DEVELOPMENT APPLICATION ASSESSMENT REPORT

Application Number:	DA2023/1224
----------------------------	-------------

Responsible Officer:	Claire Ryan
Land to be developed (Address):	Lot 4 DP 737411, 62 Myoora Road TERREY HILLS NSW 2084
Proposed Development:	Alterations and additions to the existing garden centre
Zoning:	Warringah LEP2011 - Land Zoned RU4 Primary Production Small Lots WLEP Land identified in Schedule 1 Additional Permitted Uses. Refer to attached extract of WLEP2011
Development Permissible:	Yes, under Schedule 1 Clause 18 of the Warringah LEP 2011
Existing Use Rights:	No
Consent Authority:	Northern Beaches Council
Delegation Level:	NBLPP
Land and Environment Court Action:	No
Owner:	Syesun Pty Ltd
Applicant:	LJB Urban Planning Pty Ltd

Figure 1: The extent of the building height breach to the roof above the cafe and associated outdoor seating area

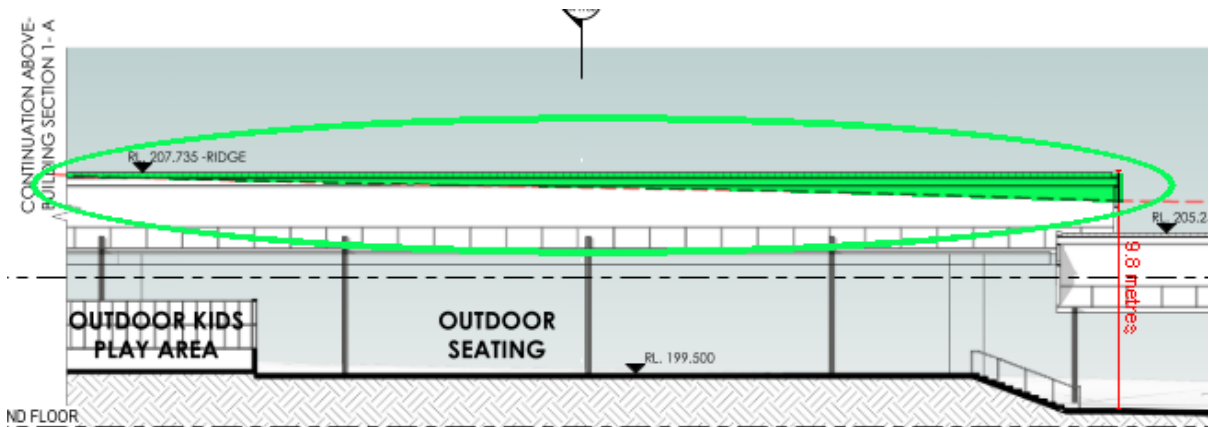
Development Standard:	Height of Buildings
Requirement:	8.5m
Proposed:	9.85m
Percentage Variation to Requirement:	15.88%

The proposed development demonstrates a height of building that is compatible with the height and scale of nearby and surrounding developments. The portions of the development that breach the height of buildings development standard are located such that they will generally not be perceptible from the public domain, and are of no impact to adjoining and surrounding land. The proposed development, also remains generally below canopy tree level, as confirmed by the supporting landscape plan, which demonstrates canopy tree plantings of between 10-12m in height, being set above the building heights proposed (9.85m).

Figure 3: The proposed breach to the maximum wall height control, on the southern elevation of the garden centre storage and staff office building (as marked in red)

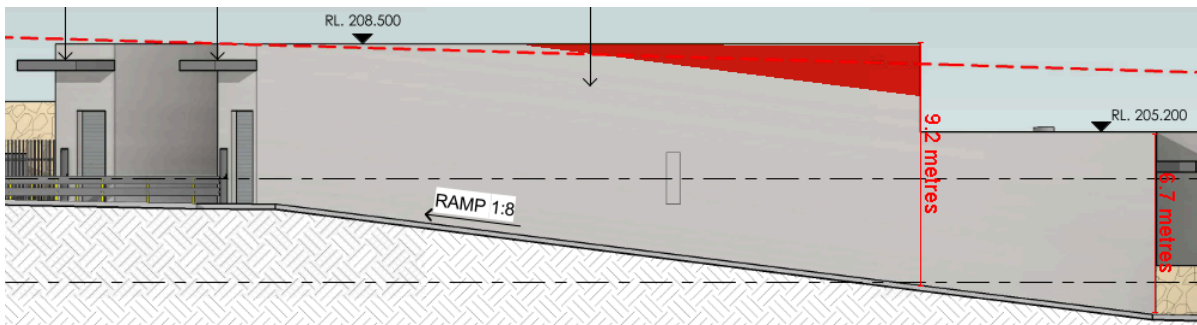
The proposed development includes a breach to the 7.2m maximum wall height control for a portion of the garden centre storage and staff office building, along the southern elevation. This elevation has a maximum wall height of 9.2m, as demonstrated below:

As shown above, the wall height non-compliance is as a result of maintaining the floor level for the relevant portion of the building in combination with the slope of the adjoining ramp. The remainder of the development is compliant with the control. With regard to the consideration for a variation, the development is considered against the underlying objectives of the control as follows:

Given the location of the building in question, being relatively central to the site, the non-compliant wall height will not be perceptible from adjoining properties, streets, waterways and land zoned for public recreation purposes. The portion of the building that is not compliant with the control is located approximately 95m from the Myoora Road frontage and 160m from the Mona Vale Road frontage. The non-compliant portion is to the southern elevation, so not visible from the northern Cooyong Road frontage.

The proposed development, despite its non-compliance with the wall height control, remains generally below canopy tree level. This is confirmed by the supporting landscape plan, which demonstrates canopy tree plantings of between 10-12m in height, where the wall height in question is 9.6m.

The proposed non-compliant wall height is designed and sited so as not to give rise to any unreasonable impacts to adjoining or surrounding land, including in relation to privacy, view sharing, and overshadowing. The non-compliant wall is set 15m from the nearest boundary, being the southern side boundary adjoining 279 Mona Vale Road, and the setback area includes a variety of planting types so as to soften the visual impact of the wall from that adjoining property.
